Stage 1 Road Safety Audit

**Neighbourhood Centre & Social Housing Scheme,
Ballyburke, Knocknacarra, Galway**

On behalf of Galway City Council

3.2.3 Disable Users Access to Footpaths

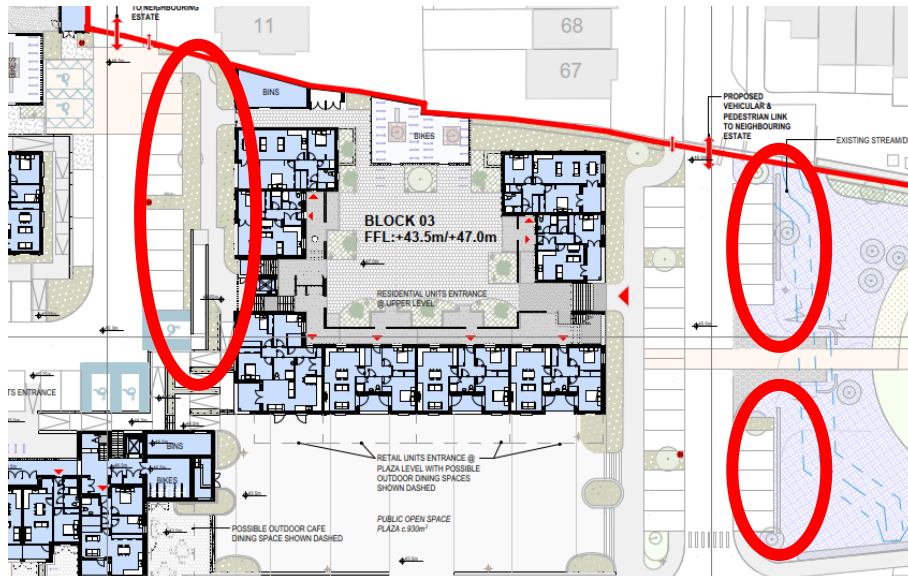
Problem: It is not clear from the drawings if the disabled user parking spaces have direct access to a suitable width, segregated footpath.

Hazard: The disabled user may be required to travel within the carriageway, to the rear of other parked vehicles in order to access a suitable footpath. Impact from vehicles egressing parking spaces or other carriageway users may result.

Recommendation: Ensure all disabled user parking spaces have a direct and suitable access to a suitable width segregated footpath.

3.2.3	Yes	Yes		
3.2.4	Yes	Yes		
3.2.5	Yes	Yes		
3.2.6	Yes	Yes		
3.2.7	Yes	Yes		
3.2.8	Yes	Yes		
3.2.9	No	No	Cyclists to use existing/proposed carriageways/footpaths to cycle/walk to next available existing connection point to existing cycleway. Connections to existing cycleway paths to be raised with GCC roads/transportation department to be considered in any future cycleway upgraded proposed in this area.	Yes

3.2.4 Access to Footpaths

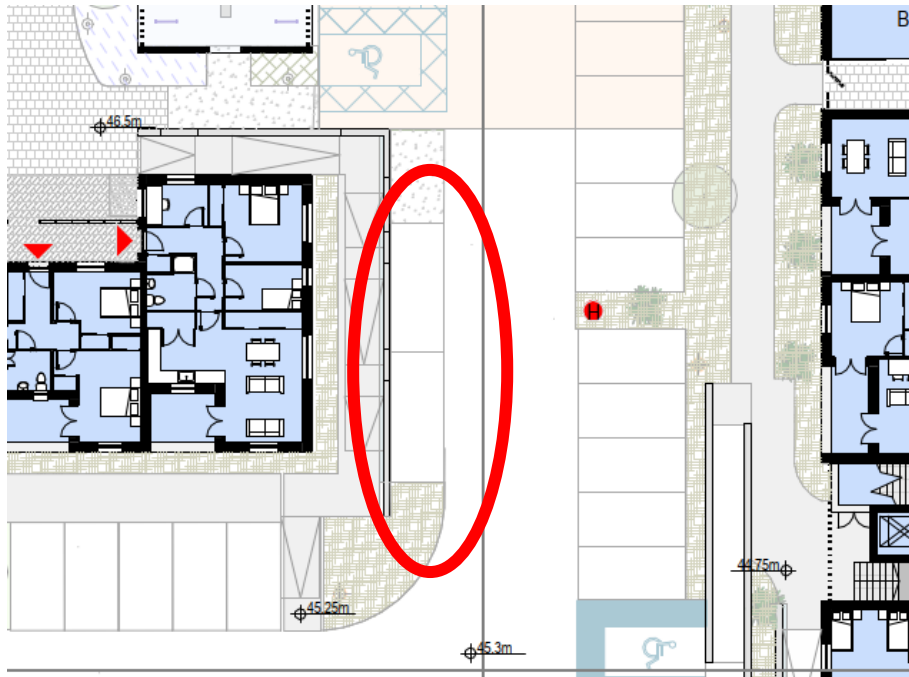
Problem: There are a number of car parking spaces that do not have access to adjacent footpaths.

Hazard: Car users are likely to walk within the carriageway in order to access the closest footpath. These users are at risk of impact from reversing or passing vehicles.

Recommendation: Provide a footpath adjacent to the car parking bays.

3.2.5 Accessible Car Parking Bays

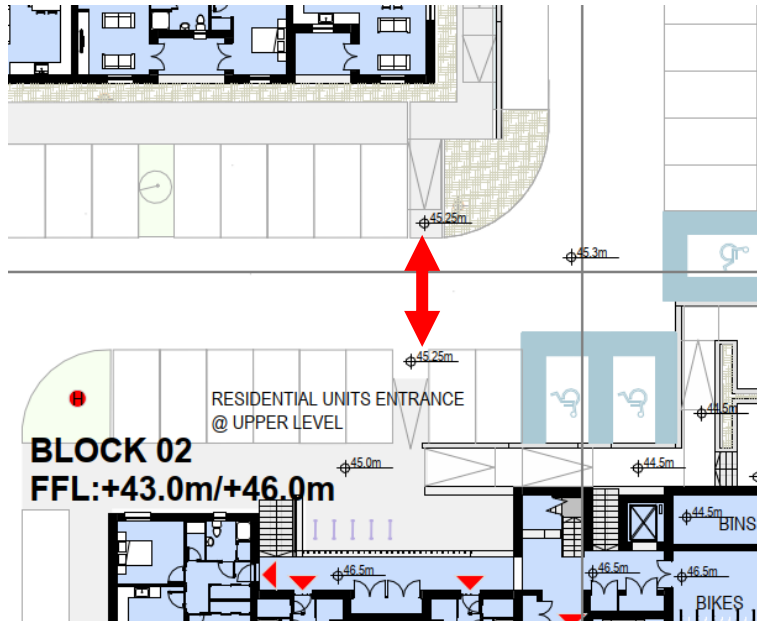
Problem: There are parallel car parking bays indicated adjacent to walls. Vehicular access to the bays is likely to be difficult. Furthermore, egress from the vehicle will be restricted due to the wall. It is likely the driver will not park within the bays but leave room between the wall and the vehicle for passenger entry/exit. The vehicle will protrude into the carriageway.

Hazard: Passing traffic may swerve to avoid the protruding vehicle and impact with opposing users.

Recommendation: Amend the design to provide adequate room for the vehicle and passenger.

3.2.6 Pedestrian Crossings in areas of Vehicle Parking.

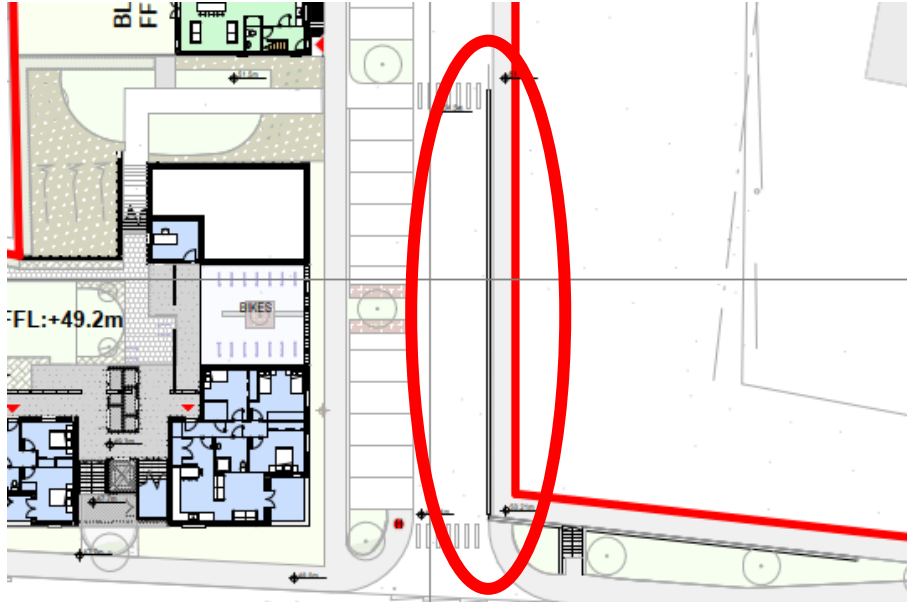
Problem: The proposed pedestrian crossing from Block 2 to Block 1 (and other locations) is shown within the car parking bays. There is concern that high sided vehicles parked within the bays may restrict inter-visibility to/from crossing pedestrians.

Hazard: Crossing pedestrians may be subject to vehicle strikes.

Recommendation: The design team should ensure suitable inter-visibility is achieved at all pedestrian crossing locations.

3.2.7 Walls Adjacent to Carriageway.

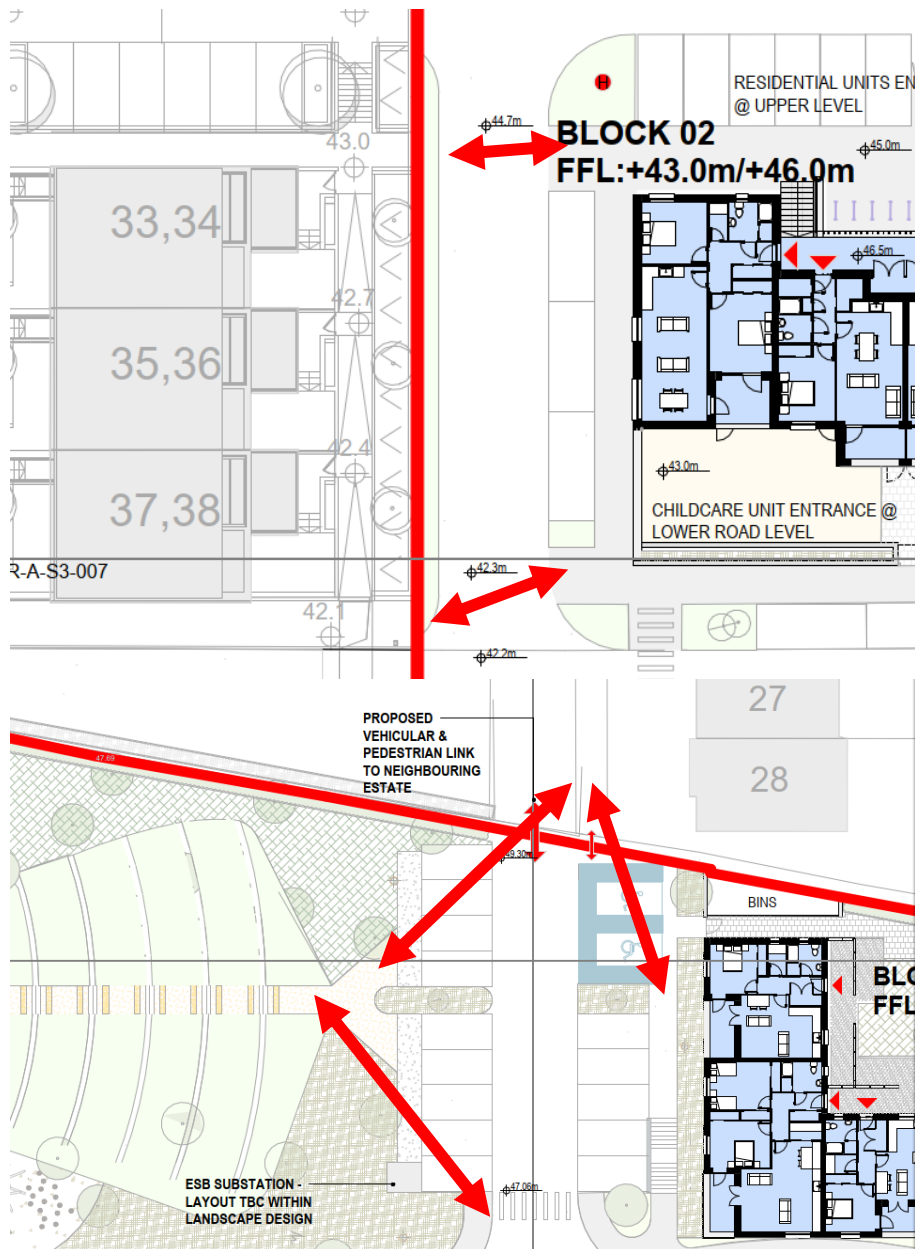
Problem: What appears to be boundary walls are shown located directly adjacent to proposed carriageways. The wall is also shown adjacent to a pedestrian crossing.

Hazard: Errant vehicles, possibly cyclists, may impact with the wall and sustain personal injury. Additionally, the wall may restrict inter-visibility to/from pedestrians waiting at the crossing.

Recommendation: Set the wall back to provide suitable clear zone and also adequate visibility for the pedestrian crossing.

3.2.9 Connection to/from Ballyburke Cycle Track

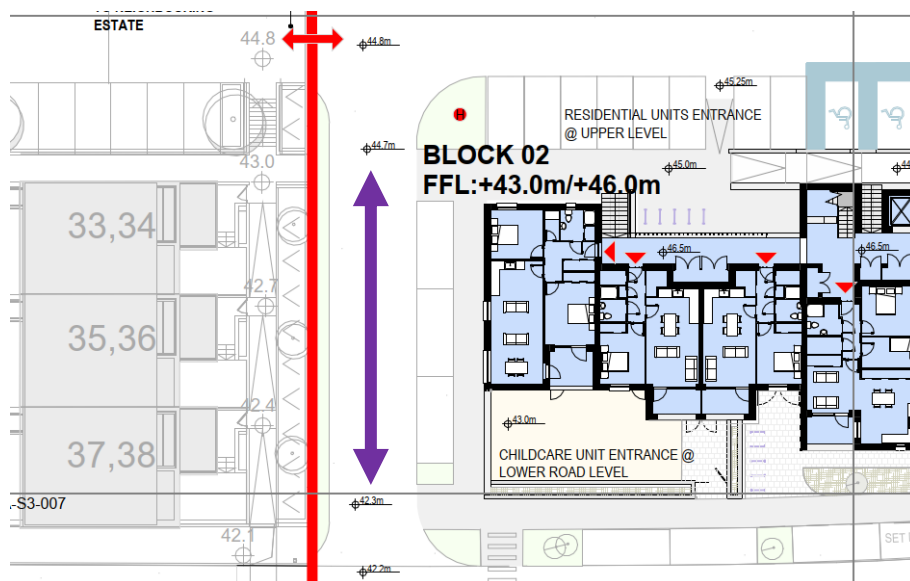
Problem: There is an existing cycle track to the south of Ballyburke Road that is segregated from both the footpath and carriageway. The proposed development does not make allowance for cyclists to access / egress this track.

Hazard: Cyclists may decide to cycle on the footpath. Impact with pedestrians may result.

Recommendation: The design team should adjust the levels of the exiting cycleway and provide suitable carriageway crossings to permit development cyclists to access the existing facility.

3.2.10 Road / Footpath Gradients

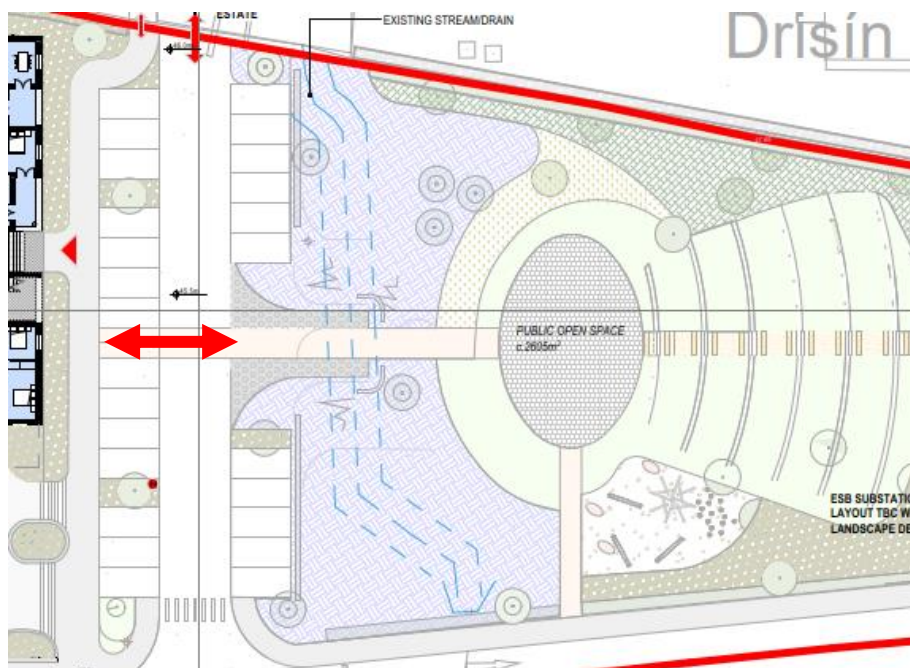
Problem: Some of the roads and footpaths appear to be very steep.

Hazard: There are a number of hazards associated with steep roads, including overshoot of junction, excessive cycle wobble into the path of motor vehicles, loss of wheelchair control, trips, slips and falls.

Recommendation: The carriageway and footpath should be amended to acceptable gradients and incorporate suitable dwell areas at the junctions.

3.2.10	No	No	Gradients of certain roadways required to deal with site constraints. Alternative part

TO BE COMPLETED BY DESIGNER				TO BE COMPLETED BY AUDIT TEAM LEADER
Paragraph No. in Safety Audit Report	Problem accepted (Yes/No)	Recommended measure accepted (Yes/No)	Describe alternative measure(s). Give reasons for not accepting recommended measure. Only complete if recommended measure is not accepted.	Alternative measures or reasons accepted by Auditors (Yes/No)
			m accessible routes for traversing the site provided elsewhere.	Yes, however gradients are to be limited to the recommendations of DMURS
3.3.1	Yes	Yes		
3.3.2	Yes	Yes

3.3.1 Pedestrian Linkage to Public Open Space.

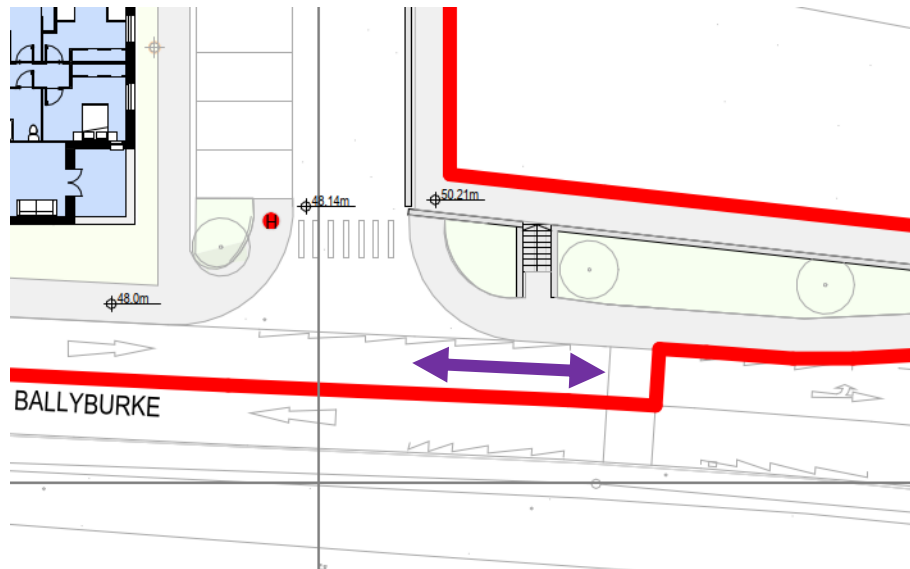
Problem: The pedestrian access from the west to the public open space forms a straight alignment from the footpath to the far side of the carriageway / car parking bays. There is concern that children may run from the public open space across the road to the footpath to the far side. There is no requirement for vehicle speeds to reduce in this area.

Hazard: Impact from passing vehicles may result.

Recommendation: Realign the route to the public open space such that a change in pedestrian direction is required and also incorporate traffic calming measures in this area.
